Access Compliance Report Public Rights-of-Way (Curb Ramps)

Main Street: OAK_KNOLL_DR Cross Street: OAK_LEAF_DR Location: SE

ADA ID: RPRK211221121909 Ramp Type: Type 1 - Perpendicular Diagonal Initial Pass/Fail: Pass Overall Compliance: No Severity Score: 10

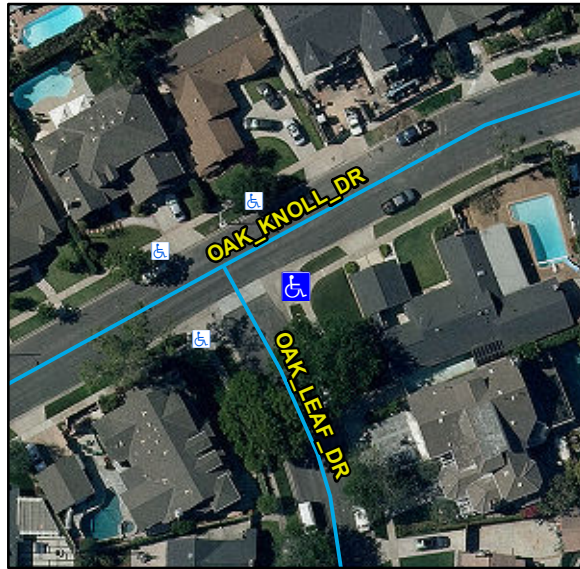
Possible Solutions:

Remove & Replace Curb Ramp With Two New Directional Ramps or Equivalent.

R204.3, R304.2.2-Perp, R304.3.2-Para, R305, STD 1115
